Access Compliance Report

Public Rights-of-Way

(Curb Ramps)

Intersection ID: 5501	Main Street: BRACHNELL_VIEW_DR	Cross Street: MALLARD_PARK_DR	Location: E
ADA ID: 17FE3F5143DF	Ramp Type: Perp	Initial Pass/Fail: Fail	Overall Compliance: No
Severity Score: 25			
Codes/Mitigation Info/Possible Solution		Field Measurements/Component Compliance

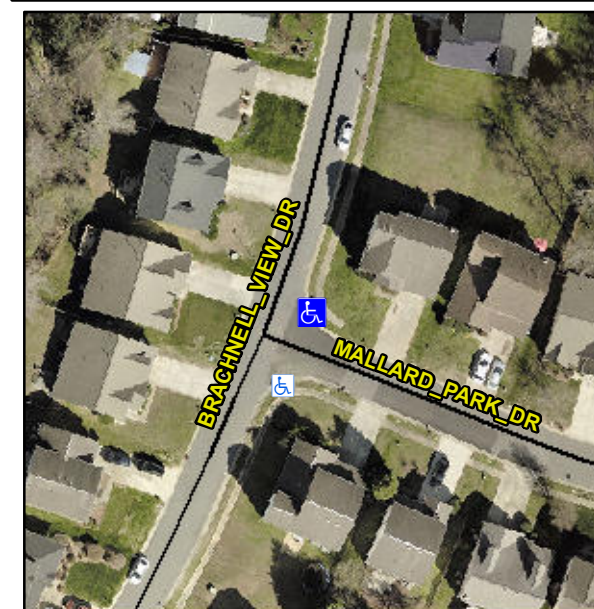
Not Found, R304.5.3

Compliance	Description	Data	Compliance	Description	Data
N/A	Ramp Length (in)	46.0	Yes	Ramp Slope (%)	6.7
Yes	Ramp Width (in)	52.0	No	Ramp XSlope (%)	7.3
N/A	Flare Type LT	N/A	N/A	Flare Type RT	N/A
N/A	Flare Slope LT (%)	N/A	N/A	Flare Slope RT (%)	N/A
N/A	Flare Traversable LT?	N/A	N/A	Flare Traversable RT?	N/A
N/A	Landing Length (in)	N/A	N/A	DWS Provided?	N/A
N/A	Landing Width (in)	N/A	N/A	DWS Contrast?	N/A
N/A	Landing Slope (%)	N/A	N/A	DWS Length (in)	N/A
N/A	Landing X Slope (%)	N/A	N/A	DWS Full Width?	N/A
N/A	Landing Curb? (Y/N)	N/A	N/A	DWS Offset (in)	N/A
N/A	Shared Landing?	N/A			
N/A	Gutter Ponding?	N/A	N/A	Gutter Slope (%)	N/A
N/A	Gutter Lip Ht (in)	N/A	N/A	Gutter X Slope (%)	N/A
N/A	Painted X Walk1?	No	N/A	Painted X Walk2?	N/A
	X Walk 1 Direction	To SW		X Walk 2 Direction	N/A
N/A	X Walk 1 Width (in)	N/A	N/A	X Walk 2 Width (in)	N/A
	X Walk 1 Slope (%)	4.2		X Walk 2 Slope (%)	N/A
	X Walk 1 X Slope (%)	3.9		X Walk 2 X Slope (%)	N/A

Remove & Replace Entire Ramp.
